Re: Paric Corporation Project No. 15051  
15051-Webster University Interdisciplinary Science Building  
CP-067 - ASI#40 - Pole for Emergency Call Box and PA Speaker

## Architect's Supplemental Instructions

**Architect's Project No:** 04561.01 **Architect's ASI No:** 040

**Project:**  
Webster University  
Interdisciplinary Science  
Building

M0401

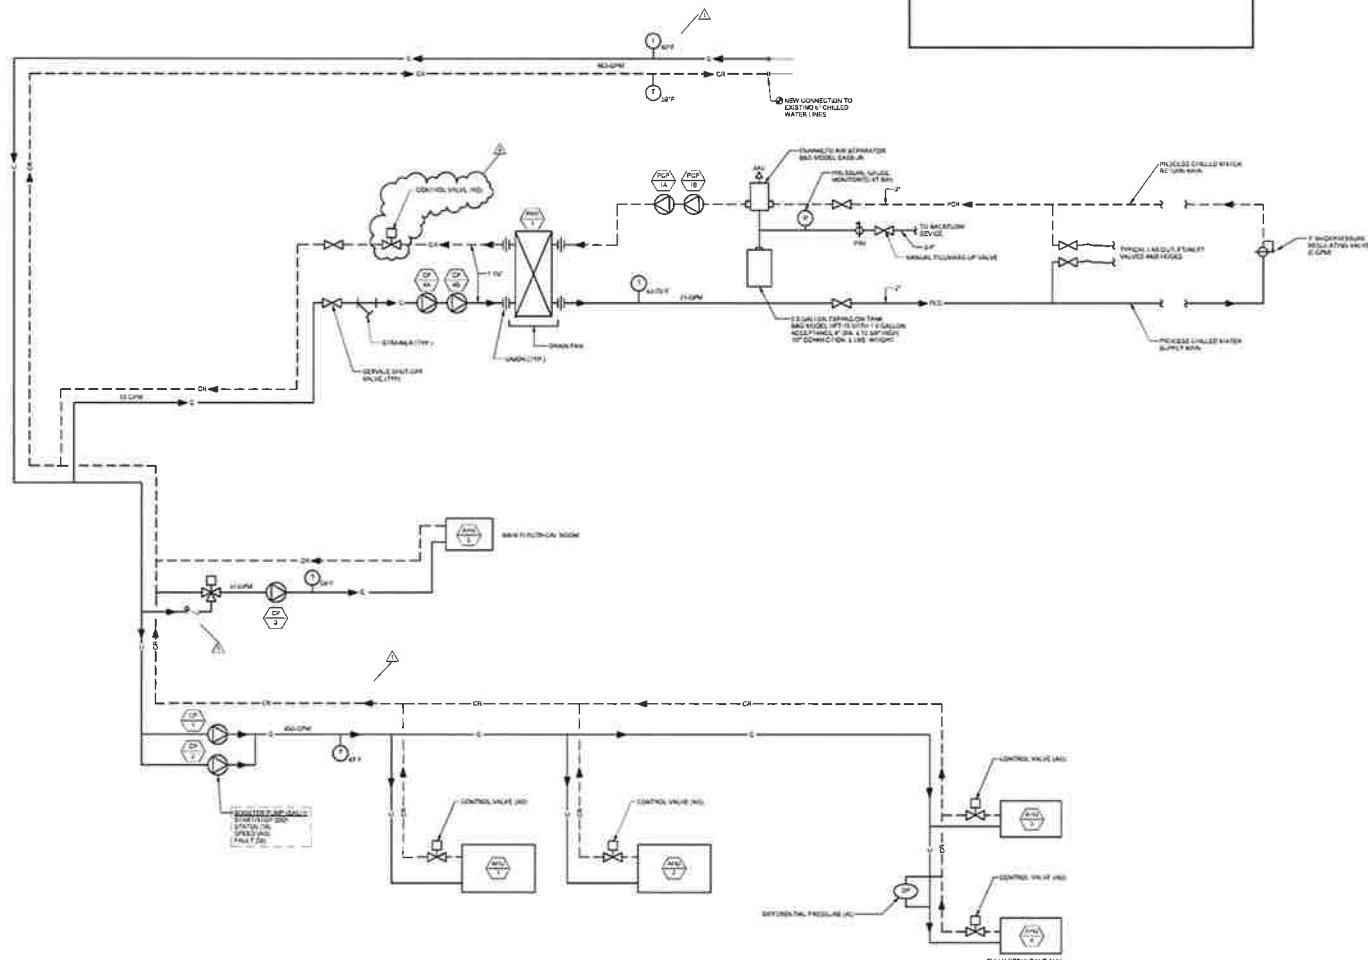
- D. Coordinate pole pre-drilling locations with owner provided equipment.
4. M0401 – DIAGRAM - MECHANICAL
  - A. Add a 2-position control valve at HX-1 as shown on piping diagram.

**3 ELECTRICAL SITE PLAN**  
1" = 20'

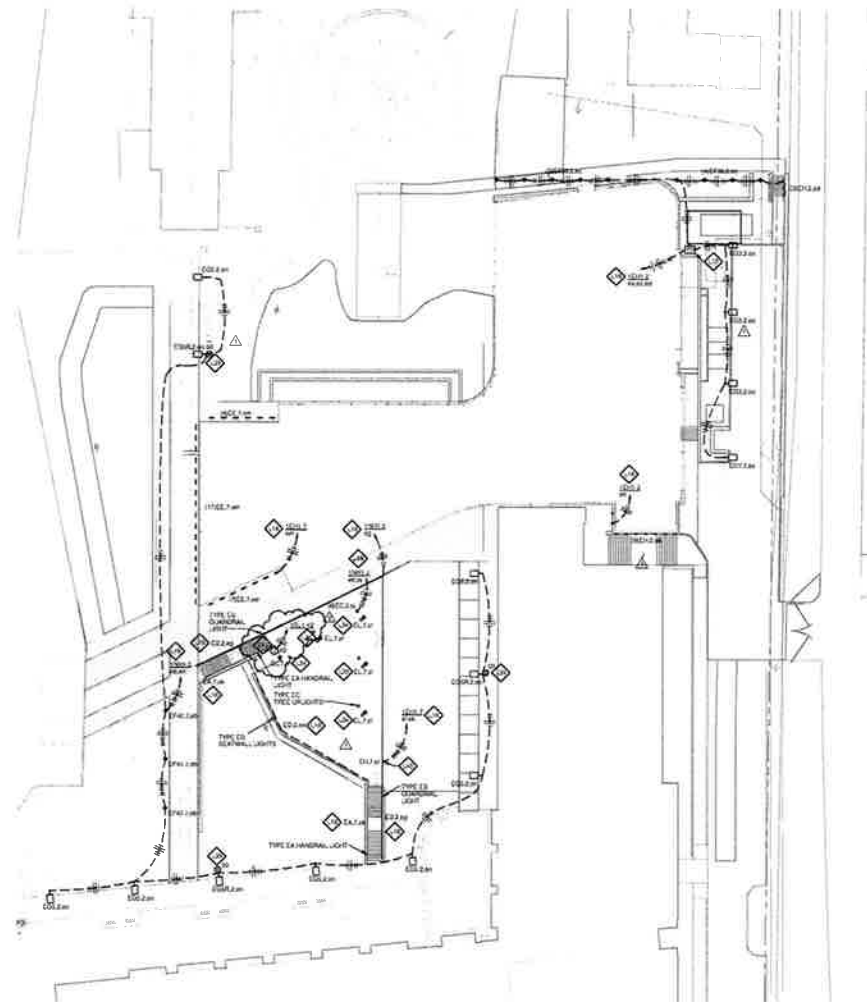
3. E0001 – ELECTRICAL SITE PLAN
  - A. Add circuit for emergency call box.
  - B. Add 12' pole for outdoor speaker and call box.
  - C. Add Keyed Note L41 to drawing.

**T0101.A**

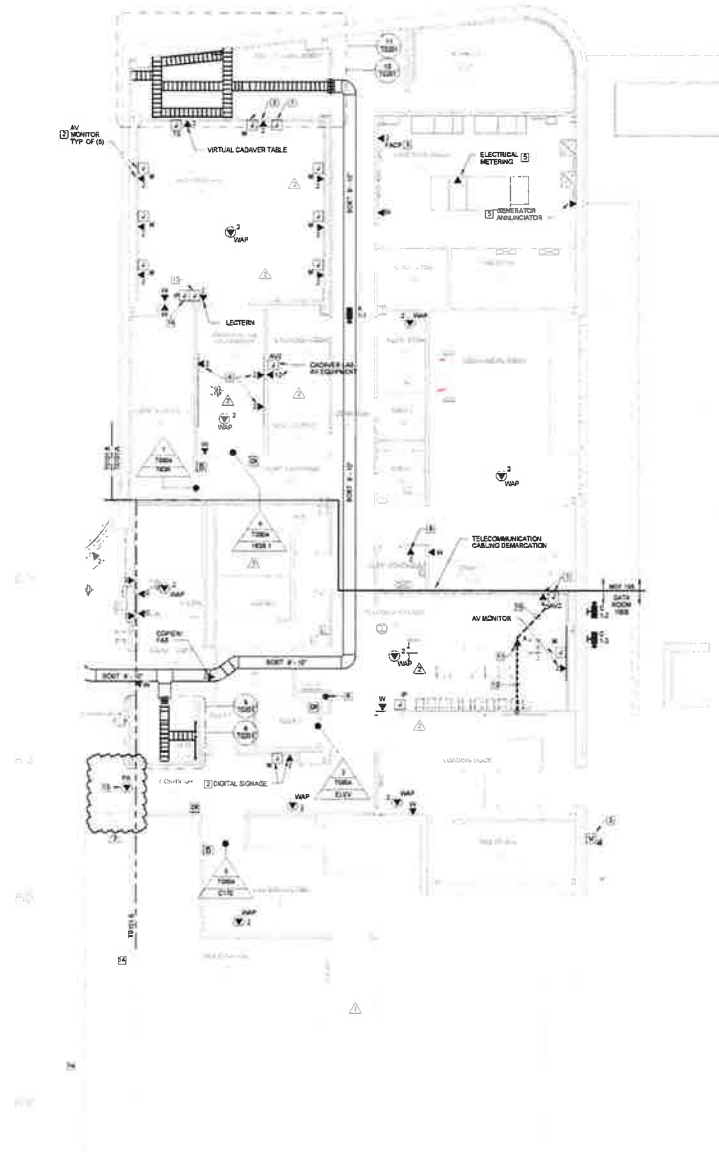
5. T0101.A – LEVEL 01 FLOOR PLAN – AREA B
  - A. Moved PA location from wall to ceiling.
  - B. Revised keyed note 13 to reflect this change.
6. T0101.B – LEVEL 01 FLOOR PLAN – AREA B

**T0102.A**

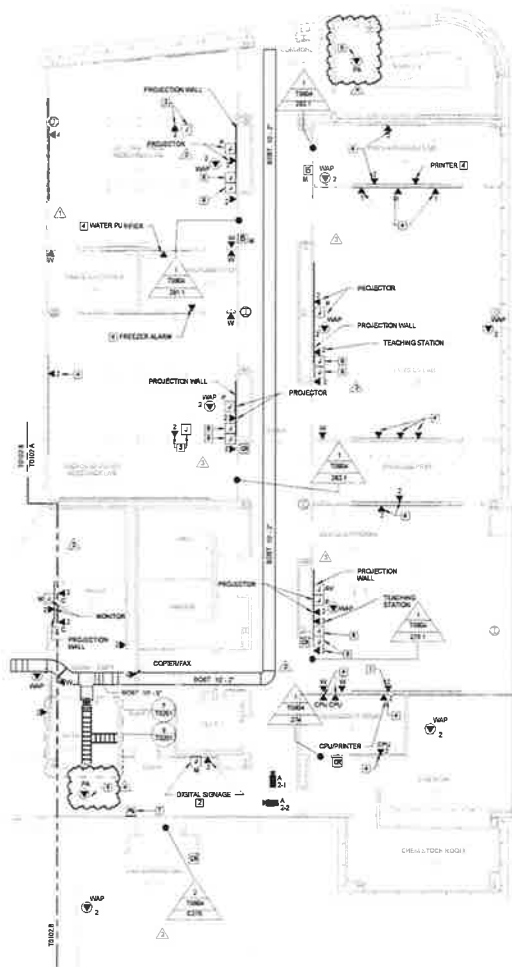
- A. Moved PA location from wall to ceiling.
  - B. Revised keyed note 6 to reflect this change.
8. T0103.A – LEVEL 03 FLOOR PLAN – AREA B
